MIL-M-28787/130A
AMENDMENT 2
31 December 1992
SUPERSEDING
AMENDMENT 1
30 November 1983

MILITARY SPECIFICATION

MODULES, STANDARD ELECTRONIC

NETWORK, MISCELLANEOUS, POWER, KEY CODE QPL

FIGURE 2 Operating temperature, component temperature, and life test circuit.

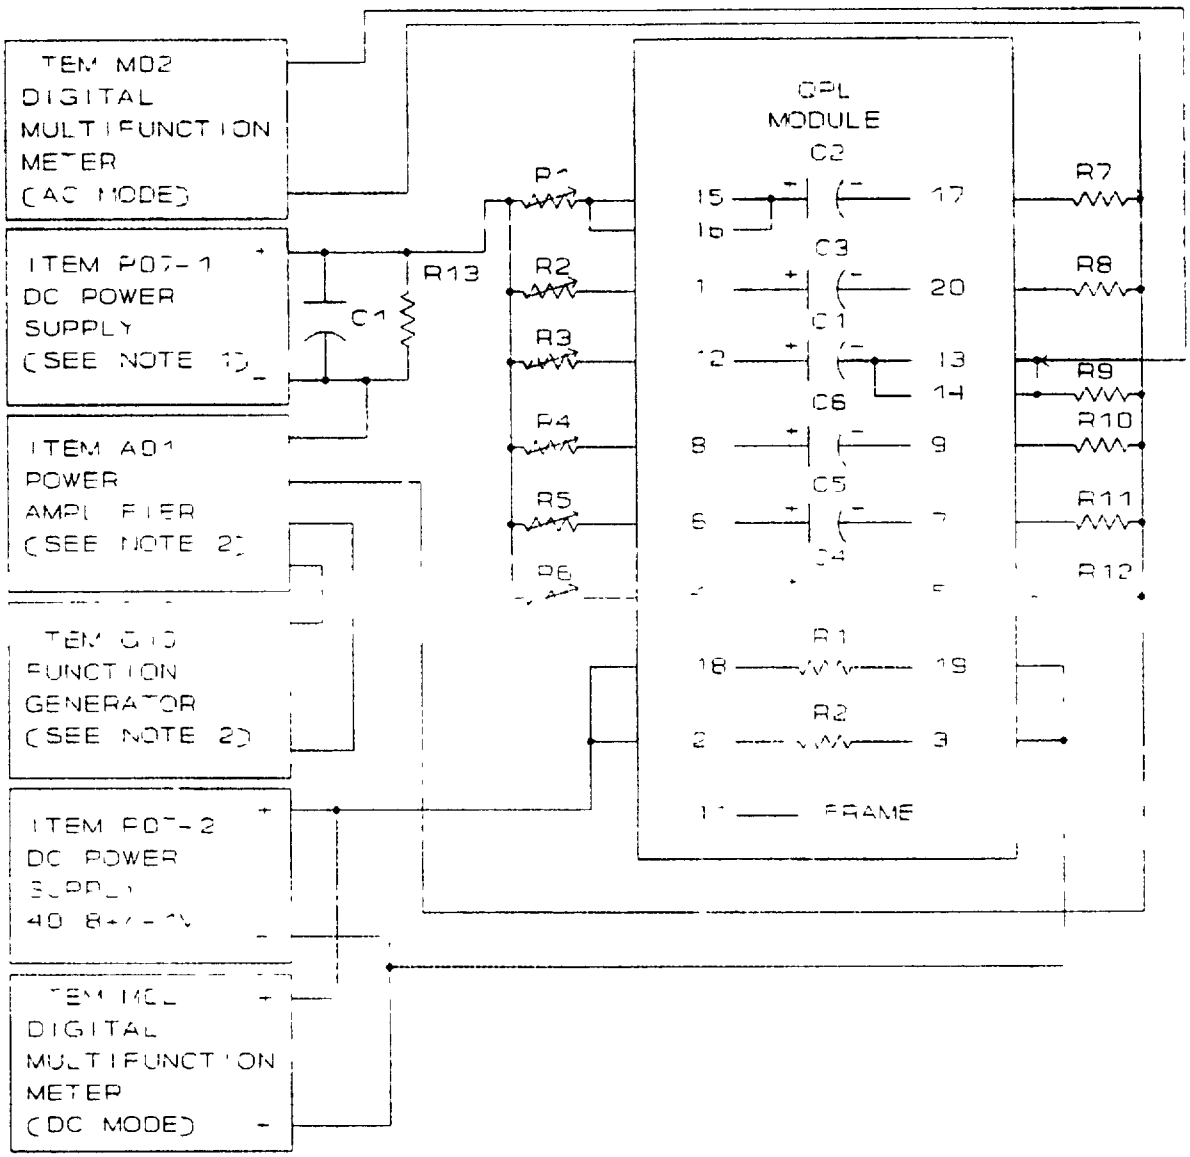
*FIGURE 2: Delete and substitute new figure 2 as printed on pages 3 and 4 of this amendment.

NOTES:
1. The ripple voltage shall be superimposed upon a direct current voltage equal to 2/3 of the specified working voltage limit.
2. An alternate power source such as a variac or powerstat and stepdown transformer with 60 Hz line input power may be used. The output voltage shall be adjusted so that the requirements of note 4 can be met.
3. Capacitors shall be energized with the following:
   (a) Ripple current rating at 60 Hz shall be 440 mArms for C2 (pins 15 and 16, to 17), C3 (pin 1 to 20), and C1 (pin 12 to 13, and 14).
   (b) Ripple current rating at 60 Hz shall be 330 mArms for C6 (pin 8 to 9), C5 (pin 6 to 7), and C4 (pin 4 to 5).
4. Adjust R1 through R6 per notes 3 (a) and 3 (b), using a voltage drop across resistors R7 through R12 to determine the current.
5. R1-R6 = 15Ω ± 10%, 4 W, variable.
6. R7-R12 = 0.1Ω ± 1%, 5 W.
7. R13 = 205Ω ± 5%, 30 W.
8. C1 ≥ 10,000 μF, 75 Vdc.

FIGURE 4. DC leakage test circuit for table III.

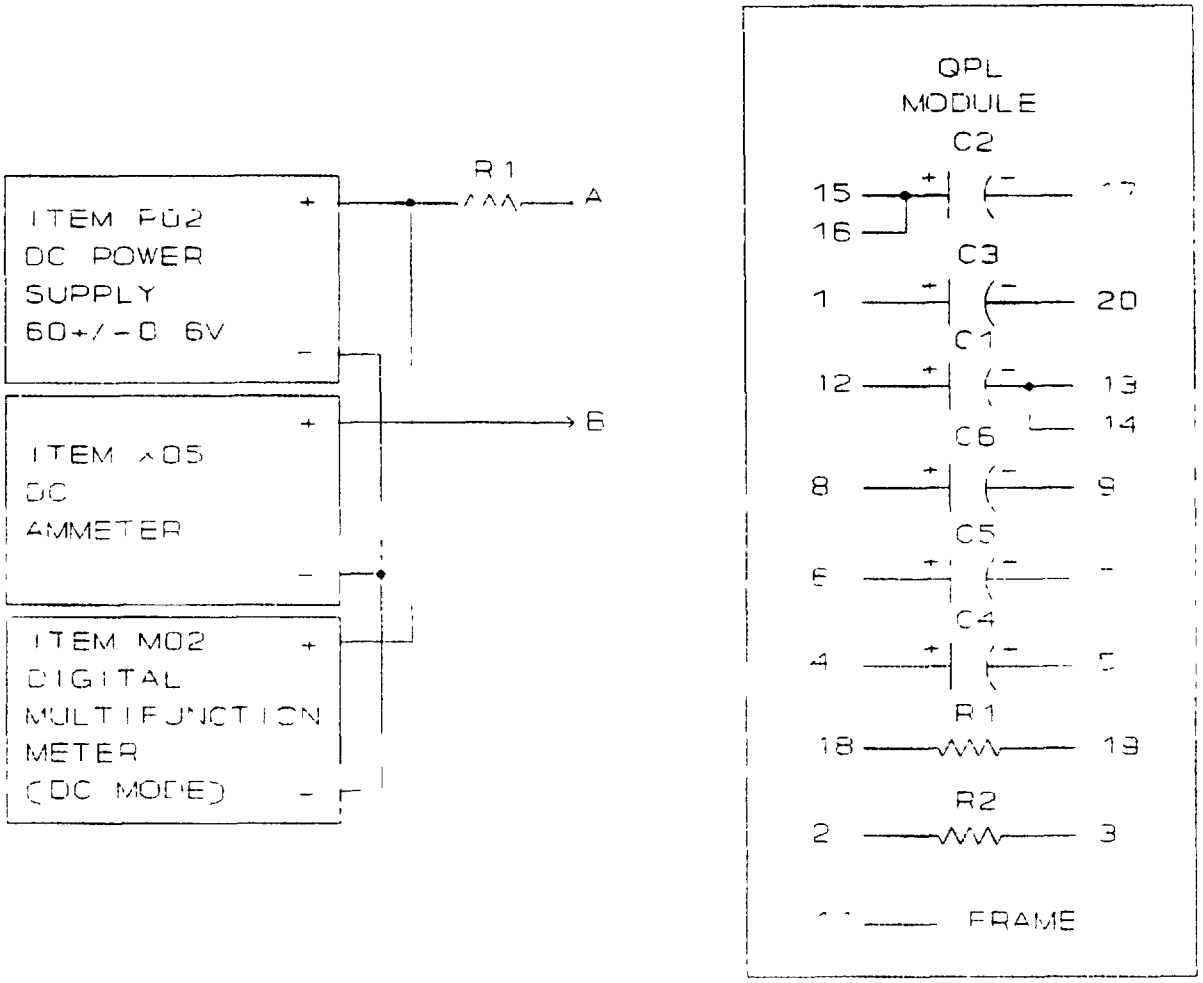
FIGURE 4: Delete and substitute new figure 4 as printed on page 5 of this amendment.

NOTES:
1. R1 = 1 kΩ ± 10%, 5 W.
2. Unit conforms to requirements if leakage drops below limit indicated in table III in five minutes or less.

FIGURE 5 Capacitance and dissipation factor test circuit for tables IV and V

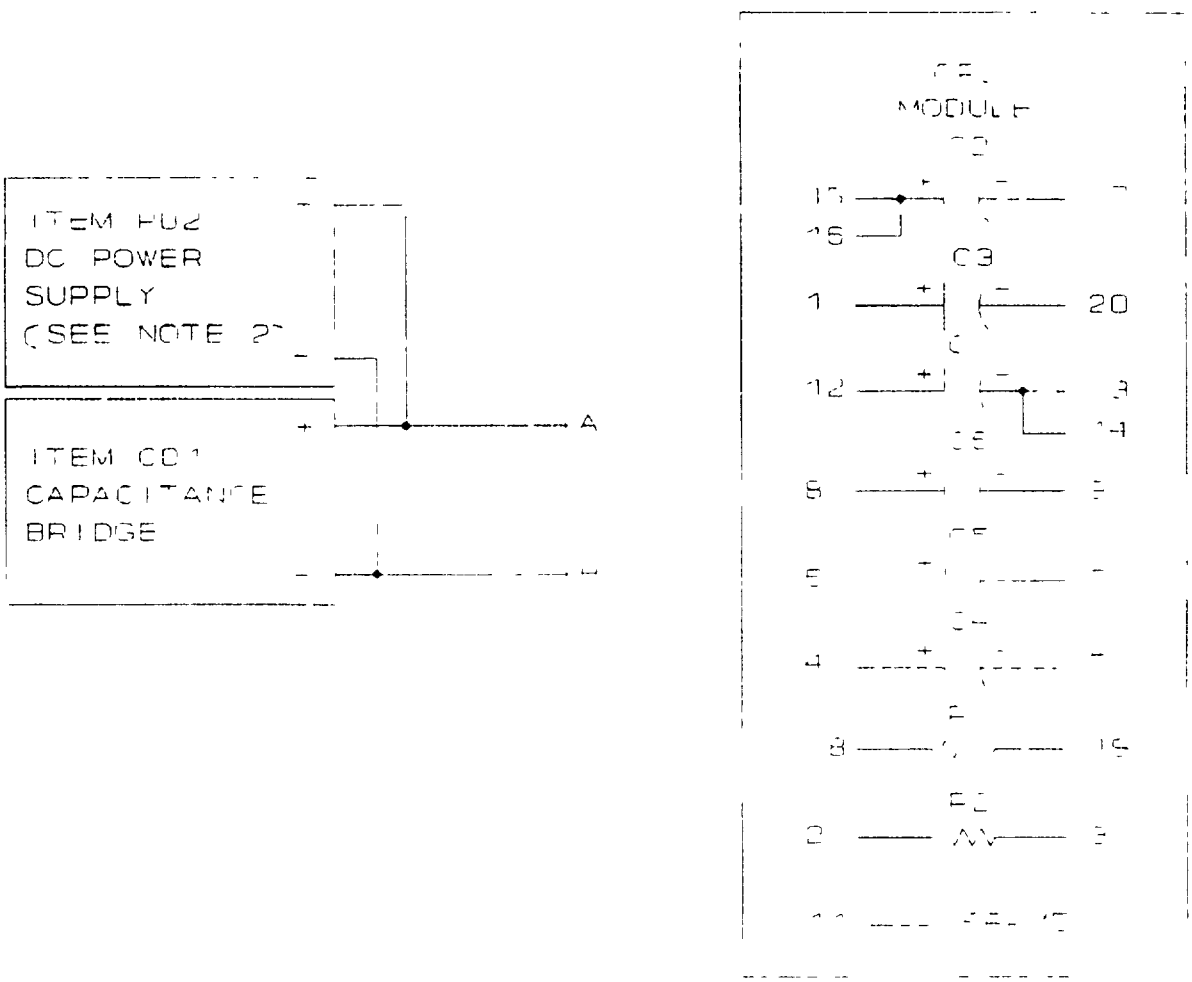
*FIGURE 5: Delete and substitute new figure 5 as printed on page 6 of this amendment.

NOTES:
1. Circuit shown for GR capacitance bridge.
2. The ac voltage shall not exceed 0.707 Vrms at 120 ± 6 Hz, this shall be superimposed on a polarizing voltage of 1.4 ± 0.1 Vdc.
3. For test conditions D1-D8, the total test circuit load resistance shall not exceed 50 milliohms.

FIGURE 6. DC resistance test circuit for table VI.

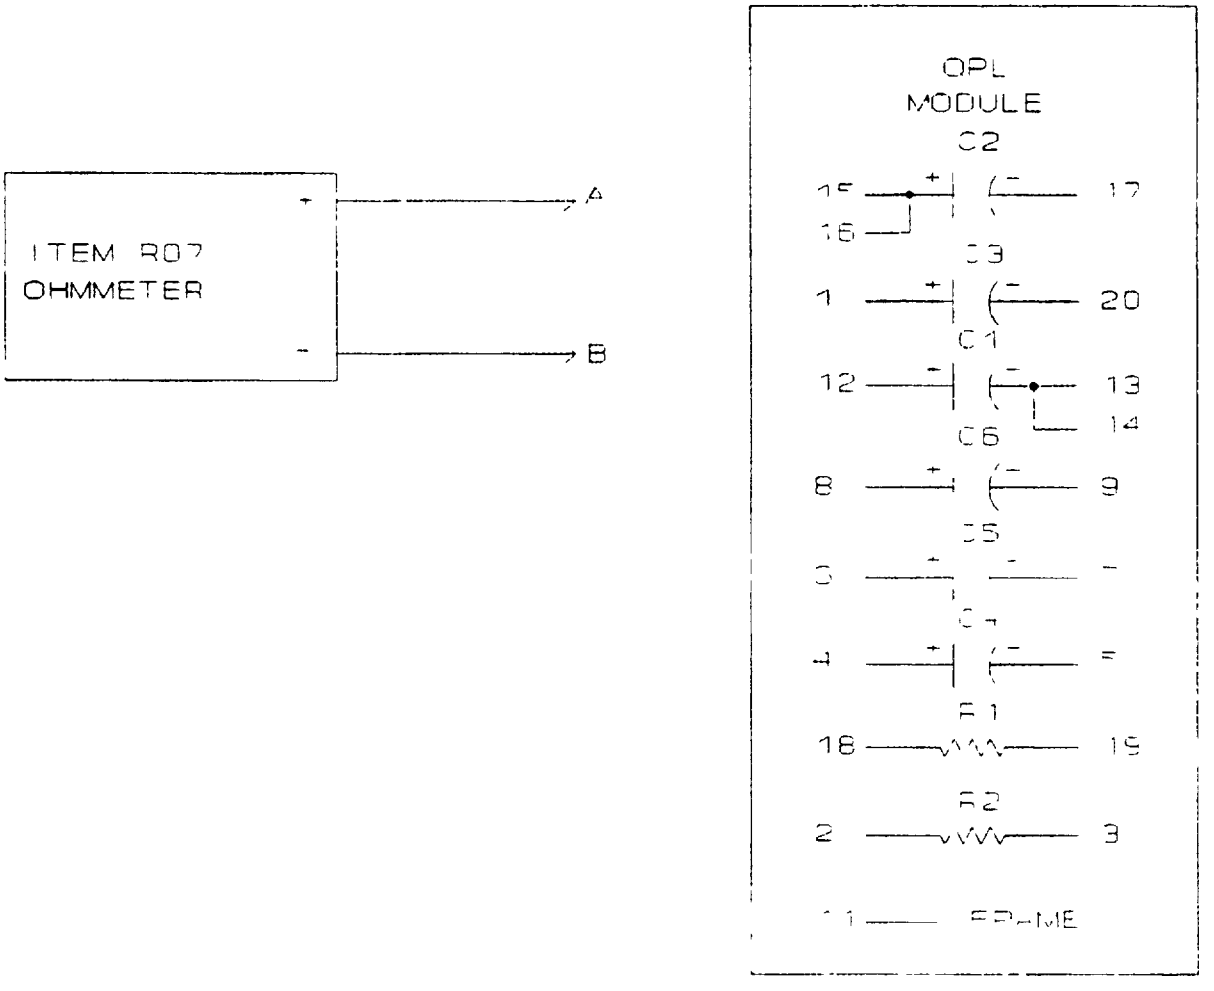
FIGURE 6: Delete and substitute new figure 6 as printed on page 7 of this amendment.

FIGURE 7. Continuity test circuit for table VII

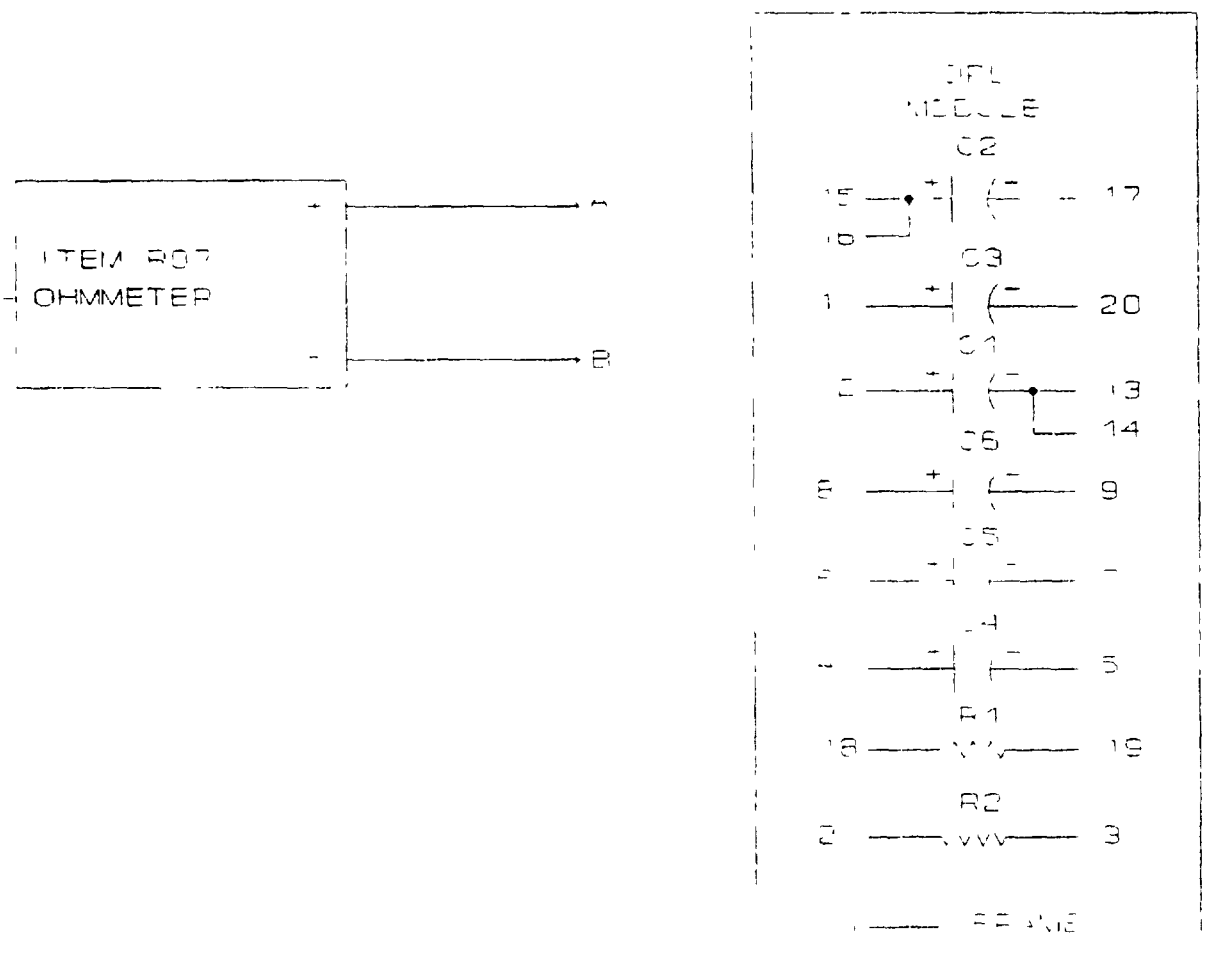
FIGURE 7: Delete and substitute new figure 7 as printed on page 8 of this amendment.

NOTE: Penetrate the anodized finish with a sharply pointed probe to obtain electrical contact.
